SR 96 Widening and Reconstruction

Value Engineering Study Report

Preliminary Design Stage

re: STP-155-1(21) CSNHS-0008-00(406)(407)
P.I. Nos. 322450, 0008046, 0008407
SR 96 Widening and Reconstruction Project
Houston and Peach Counties, Georgia
Value Engineering Study Report

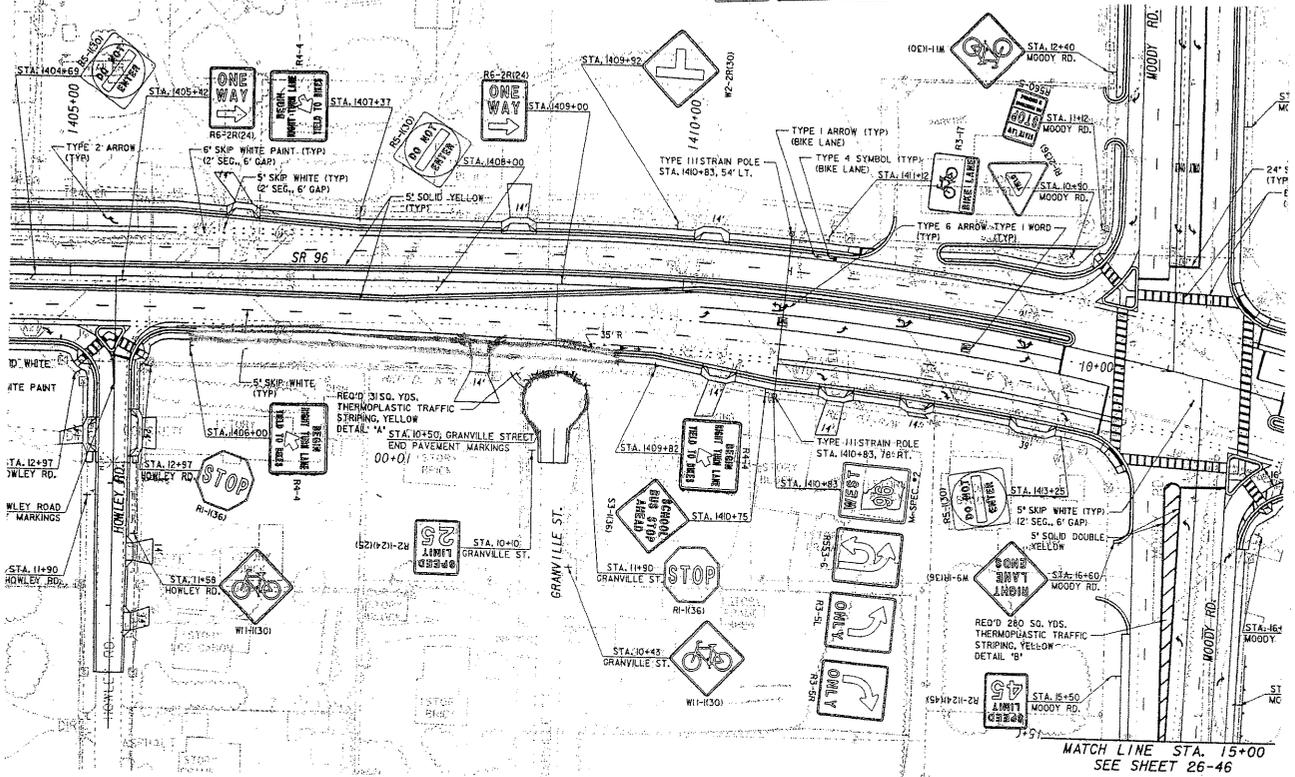
| ALT. NO. | DESCRIPTION | ORIGINAL COST | ALTERNATIVE COST | INITIAL COST SAVINGS | RECURRING COST SAVINGS | TOTAL PW LCC SAVINGS |
|-----------------------------|---|---------------|------------------|----------------------|------------------------|----------------------|
| I-1 | Cul-de-sac Granville Drive | | | | DESIGN SUGGESTION | |

I-2 3 of 4
 SHEET NO.:

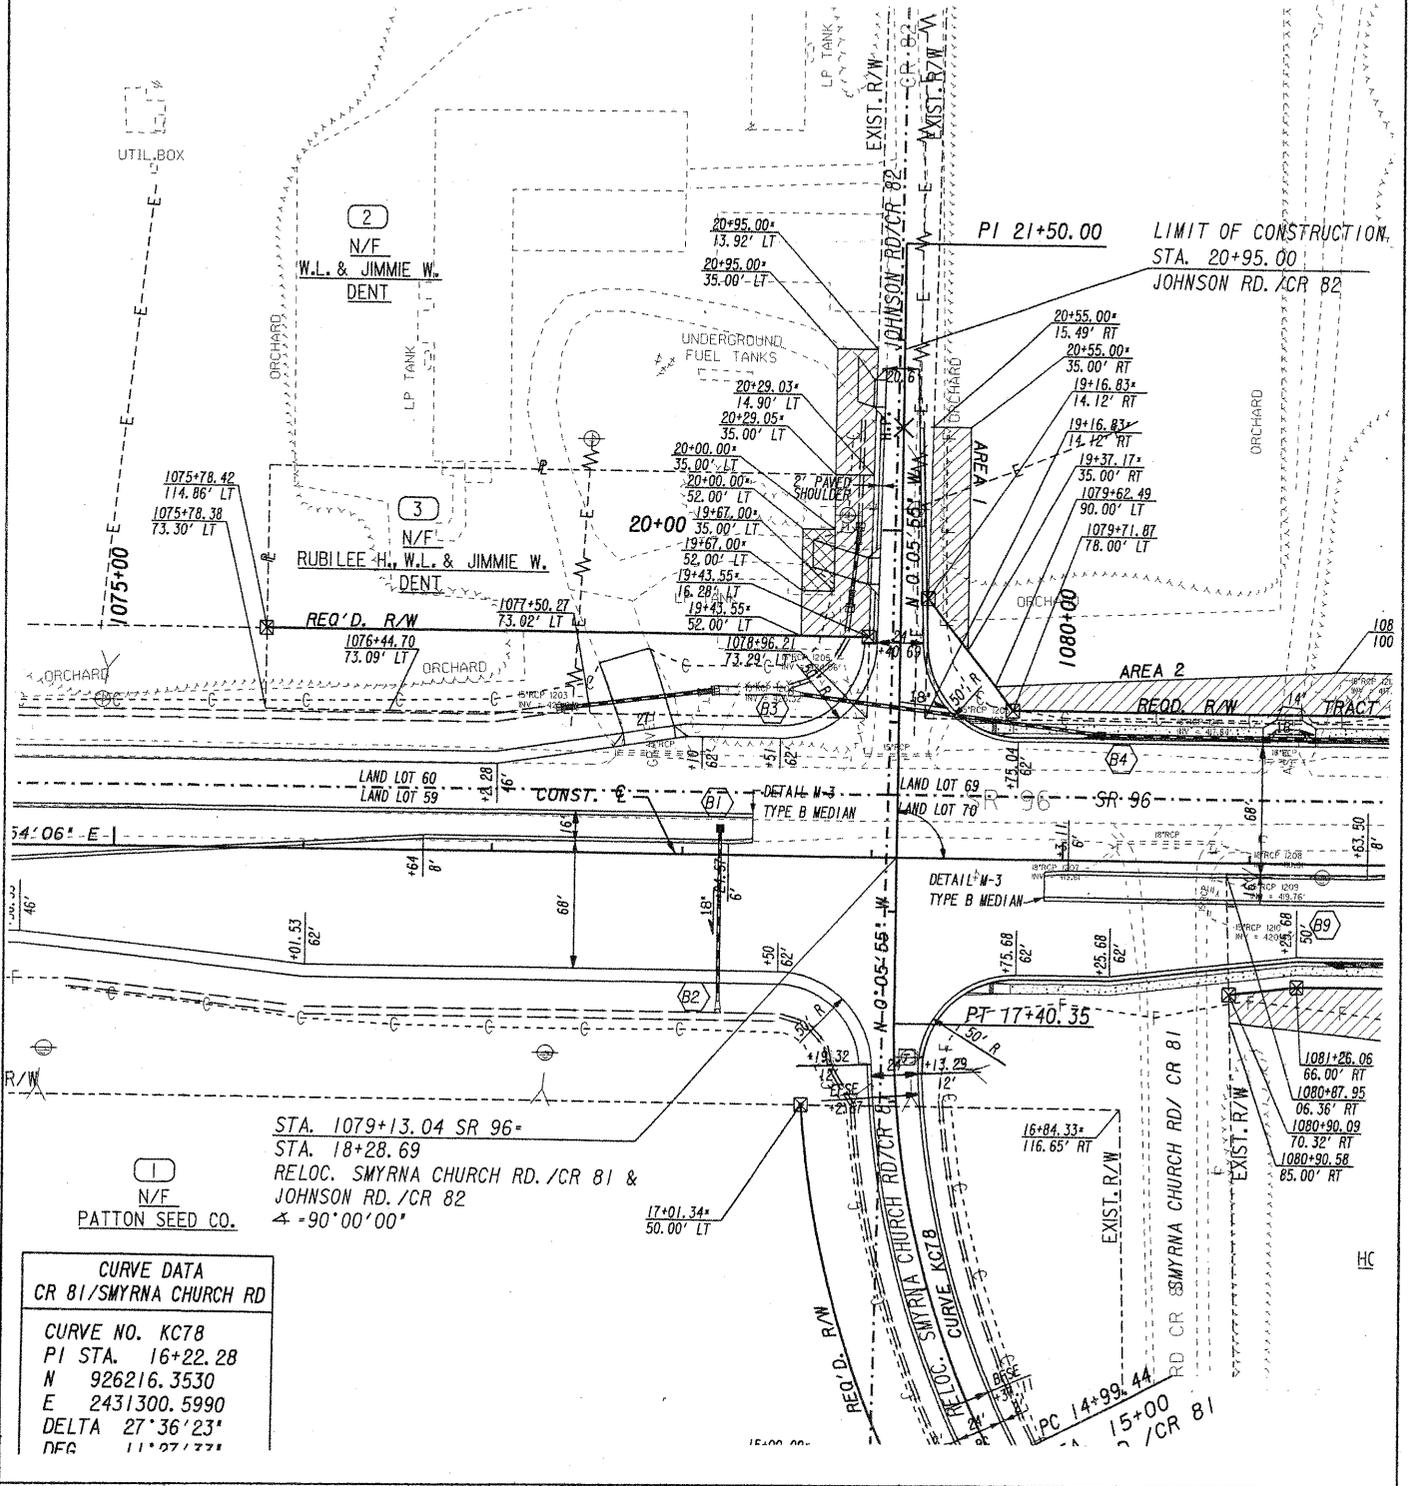
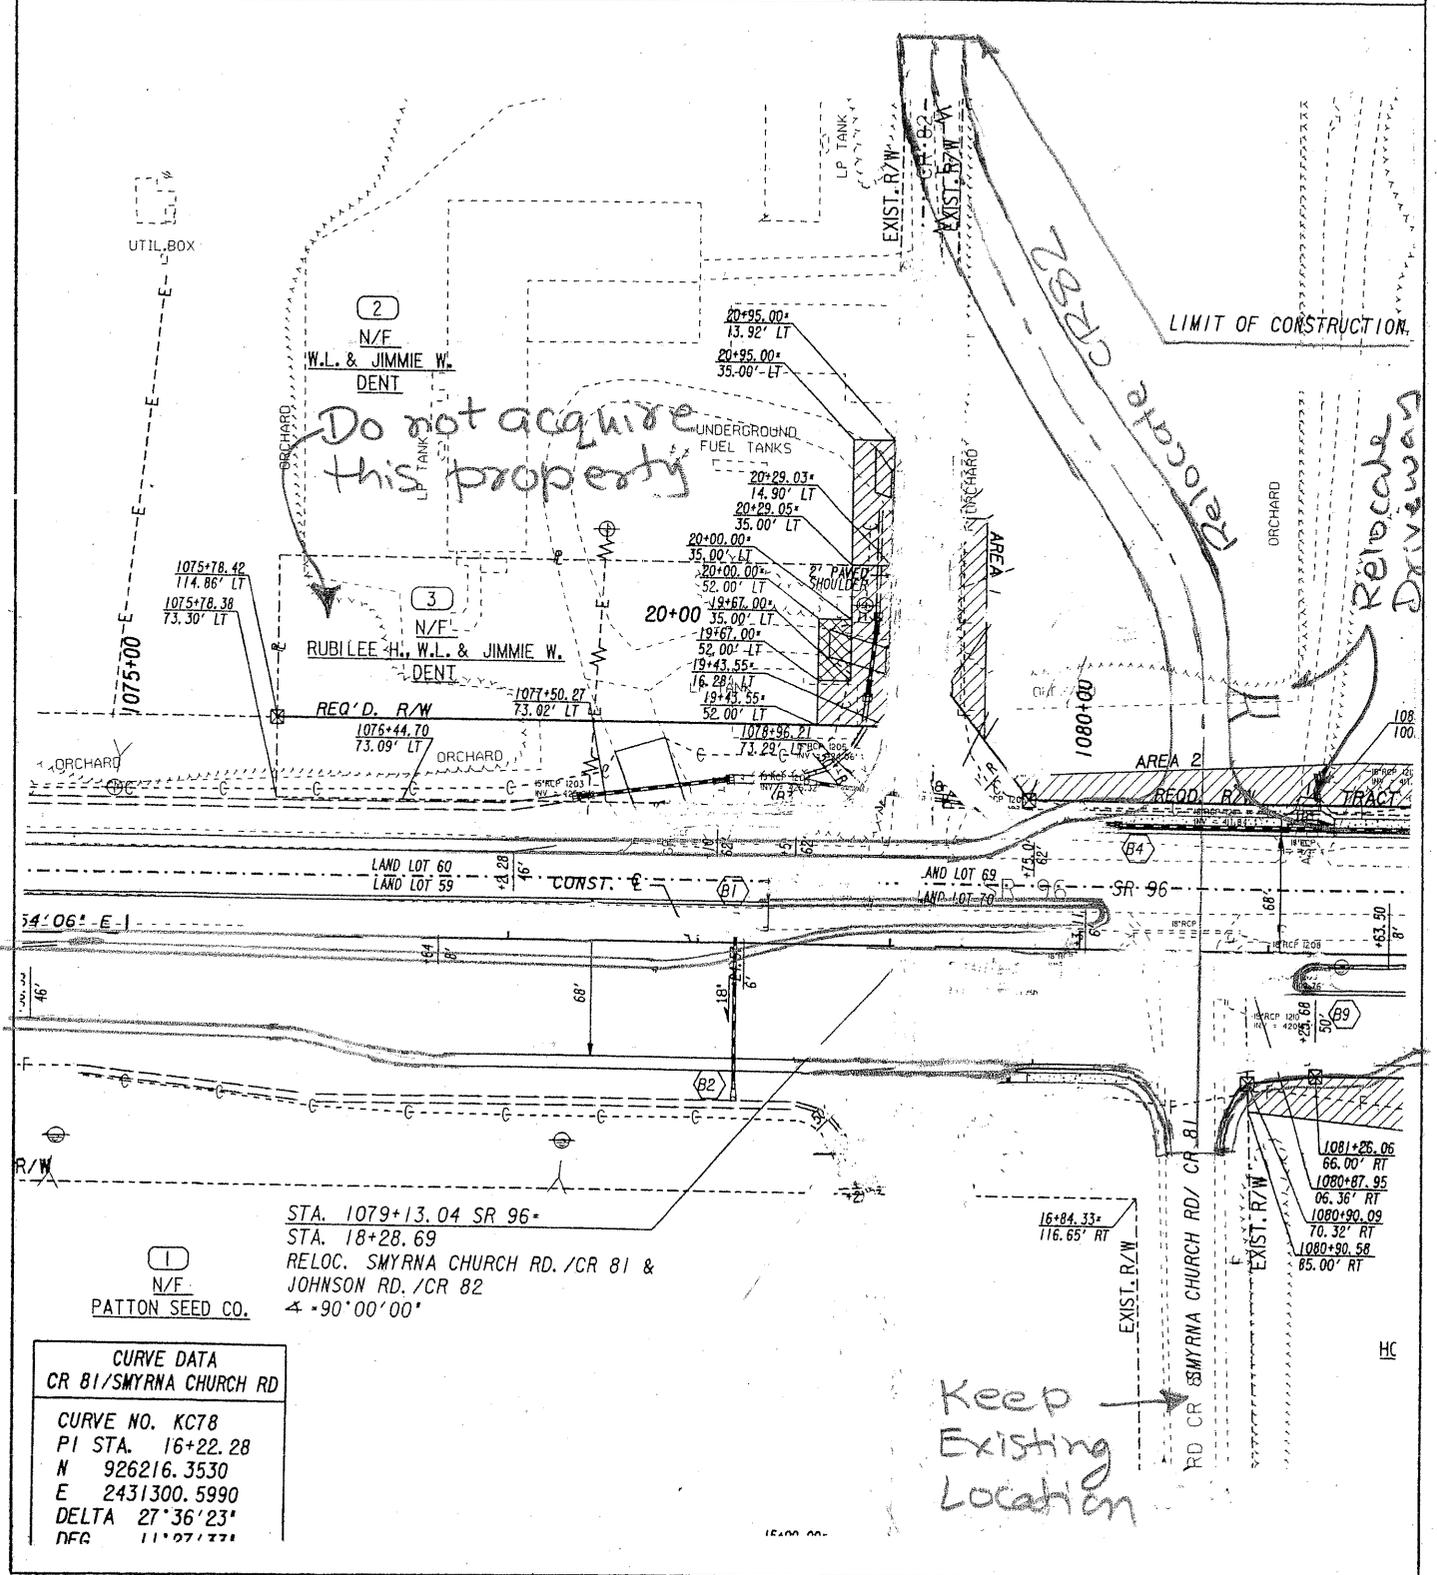
| ALT. NO. | DESCRIPTION | ORIGINAL COST | ALTERNATIVE COST | INITIAL COST SAVINGS | RECURRING COST SAVINGS | TOTAL PW LCC SAVINGS |
|-----------------------------|---|---------------|------------------|----------------------|------------------------|----------------------|
| I-2 | Align the CR 82/CR 81 intersection with a realignment of CR 82 | \$ 216,400 | \$ - | \$ 216,400 | | \$ 216,400 |

I-6

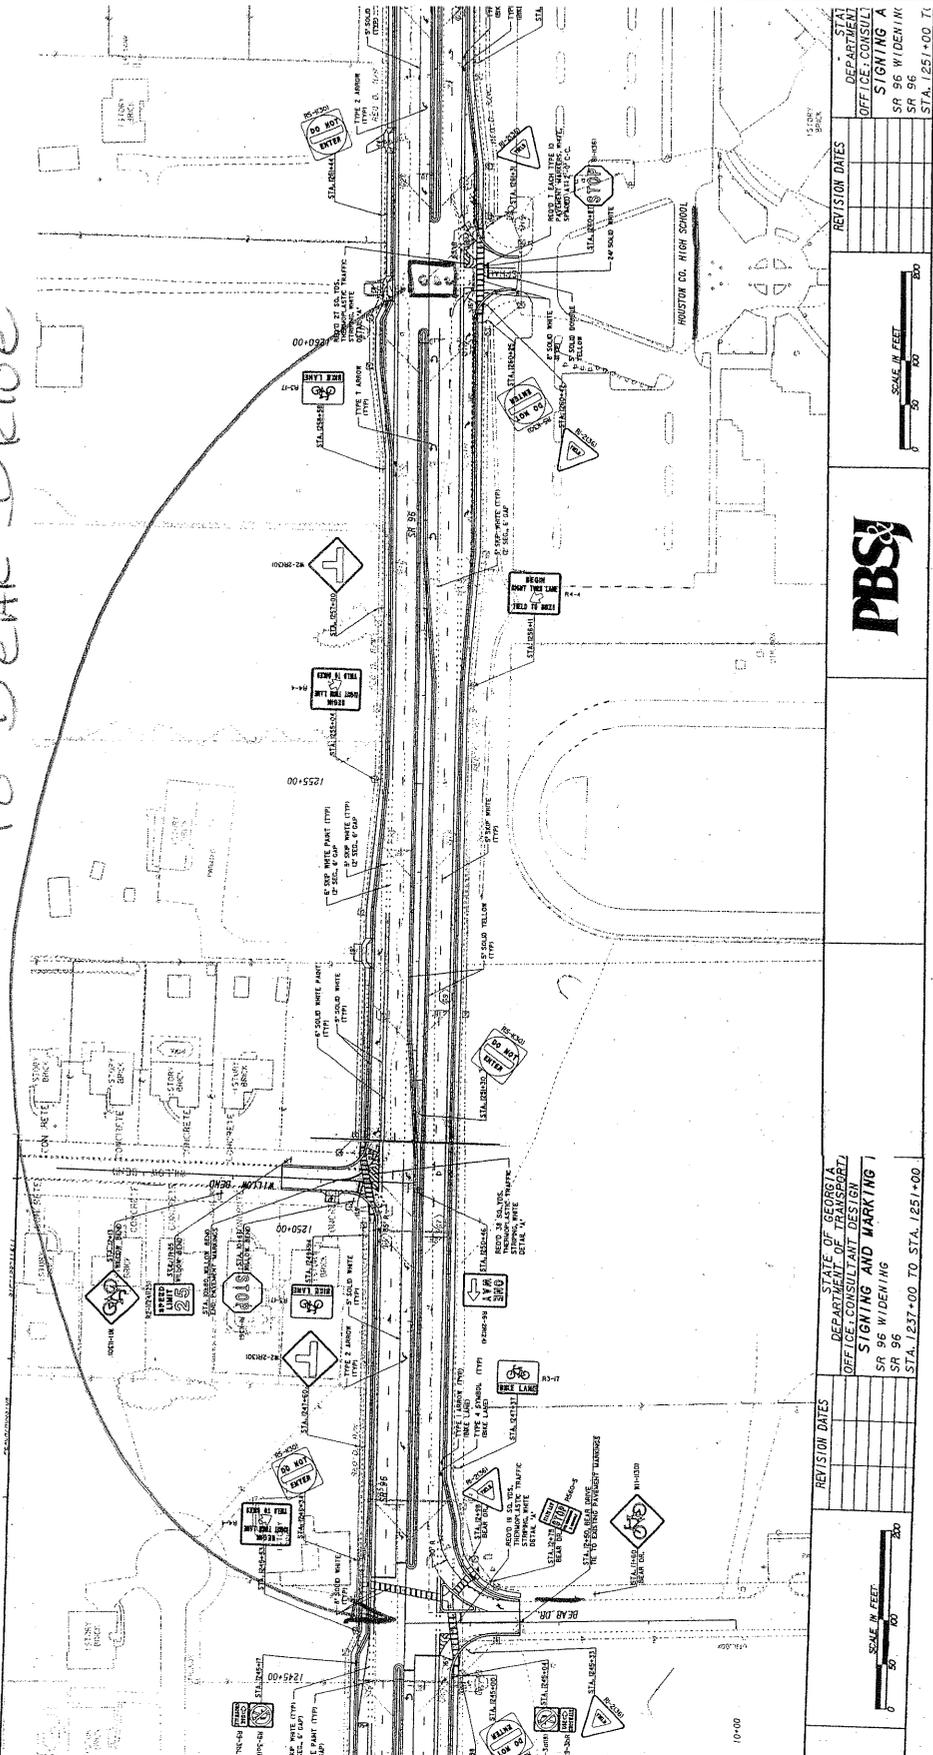
| ALT. NO. | DESCRIPTION | ORIGINAL COST | ALTERNATIVE COST | INITIAL COST SAVINGS | RECURRING COST SAVINGS | TOTAL PW LCC SAVINGS |
|-----------------------------|---|---------------|------------------|----------------------|------------------------|----------------------|
| I-6 | Signalize Bear Drive/SR 96 intersection in lieu of High School Drive/SR 96 access point | | | | DESIGN SUGGESTION | |

ALTERNATIVE NO.: *B-2 A*

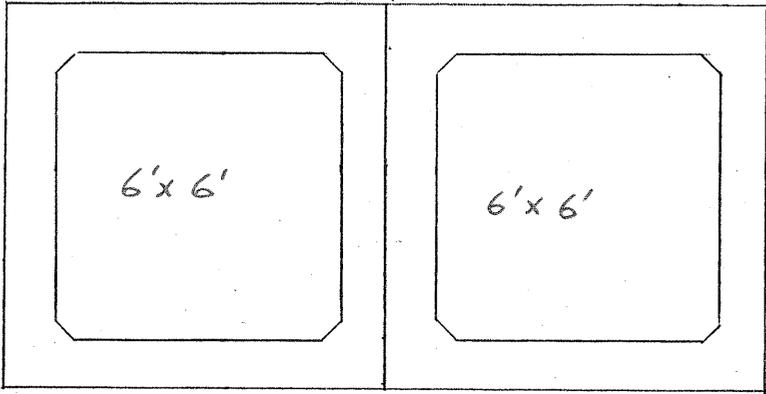
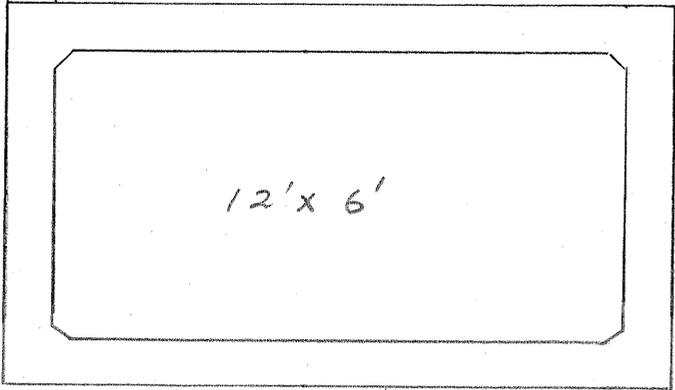
| ALT. NO. | DESCRIPTION | ORIGINAL COST | ALTERNATIVE COST | INITIAL COST SAVINGS | RECURRING COST SAVINGS | TOTAL PW LCC SAVINGS |
|-----------------------------|---|---------------|------------------|----------------------|------------------------|----------------------|
| B-2A | In lieu of a double 6-ft. x 6-ft. box culvert, consider a single 12-ft. x 6-ft. box culvert at Station 1452+17 | \$ 75,161 | \$ 126,553 | \$ (51,392) | | \$ (51,392) |

ALTERNATIVE NO.: *B-2B*

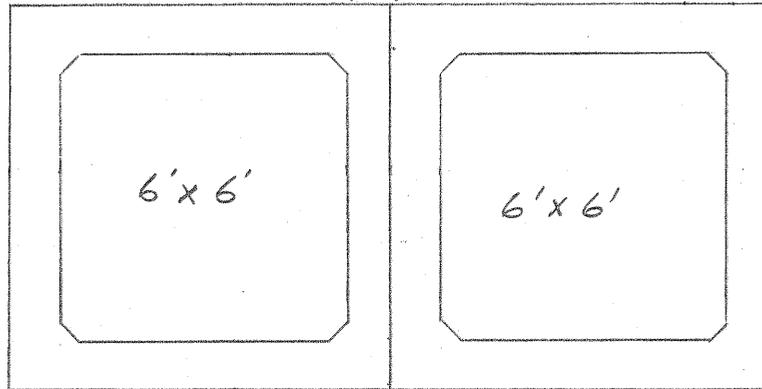
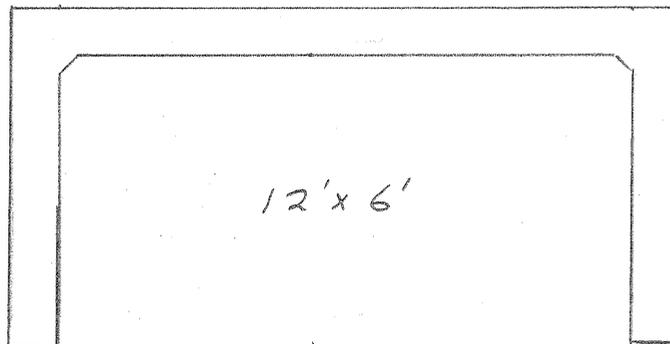
| ALT. NO. | DESCRIPTION | ORIGINAL COST | ALTERNATIVE COST | INITIAL COST SAVINGS | RECURRING COST SAVINGS | TOTAL PW LCC SAVINGS |
|-----------------------------|---|---------------|------------------|----------------------|------------------------|----------------------|
| B-2B | In lieu of a double 6-ft. x 6-ft. box culvert, consider a single 12-ft. x 6-ft. three-sided concrete culvert at Station 1452+17 | \$ 75,161 | \$ 235,118 | \$ (159,957) | | \$ (159,957) |

ALTERNATIVE NO.: *B-4*

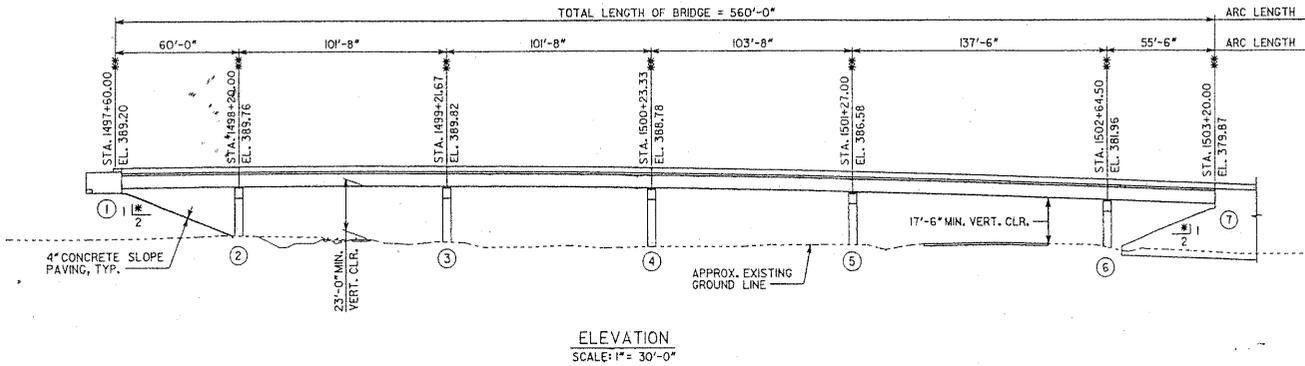
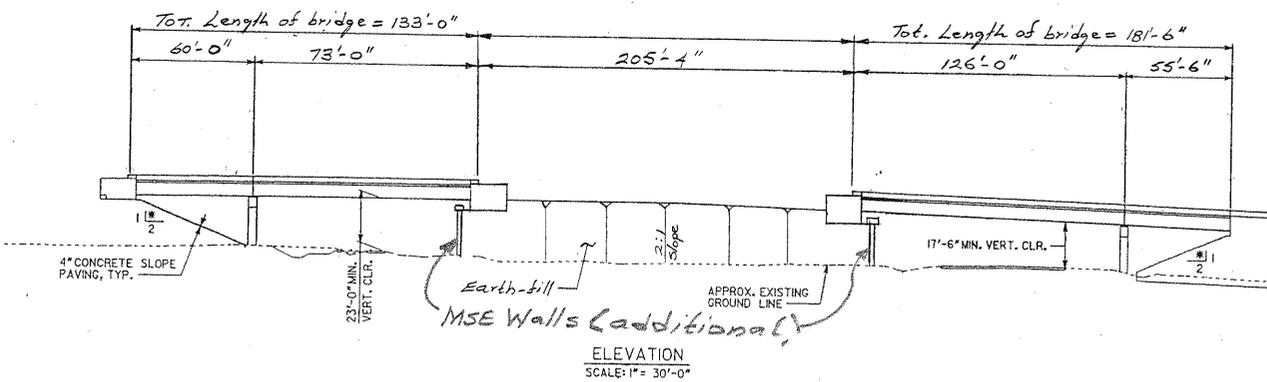
Fill spans 3 and 4 with earth-filling and revise the lengths of spans 1, 2, 5 and 6. Convert intermediate bents 3 and 5 to end bents. Provide MSE walls in front of the end bents to retain earth-fill. MSE walls to be installed parallel to the centerline of the railroad and SR-247.

ALTERNATIVE NO.: *B-5*

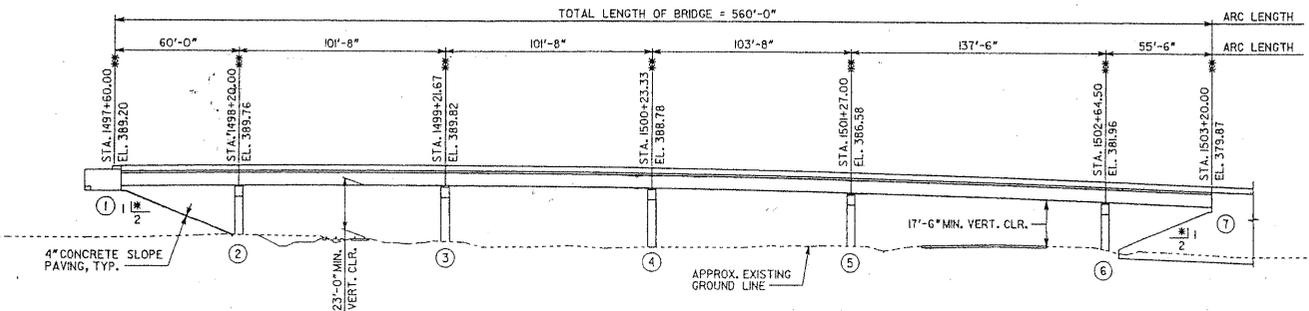
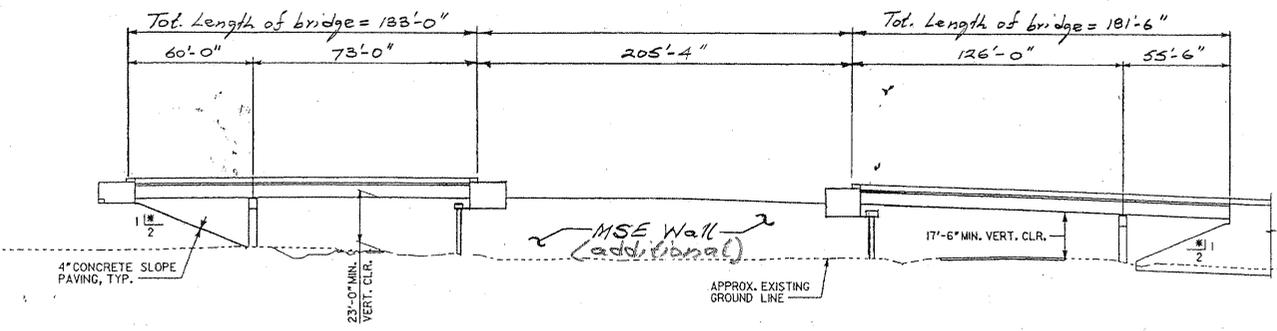
Fill spans 3 and 4 with earth-fill and revise the lengths of spans 1, 2, 5 and 6. Convert intermediate bents 3 and 5 to end bents. Install MSE walls to retain the earth-fill on all four sides.
